Product Change Notification

Change Notification #: 115088-00
Change Title: Intel® Server System R2308WTTYSR, PCN115088-00, Product Design, Hot Swap Back Plane Sheet Metal Locator Tab Modification

Date of Publication: November 15, 2016

HSBP Locator tab

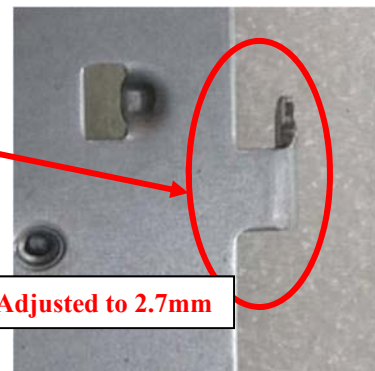
1. The sheet metal of the locator at the bottom tab of the hot swap back plane (HSBP) in the right side will be modified to ensure gap of 2.7mm. This modification is needed to provide reliable engagement between the drive and the backplane connectors. Please see additional information in the TA-1107 available at: <http://www.intel.com/content/www/us/en/support/server-products/000022064.html?wapkw=ta-1107>.
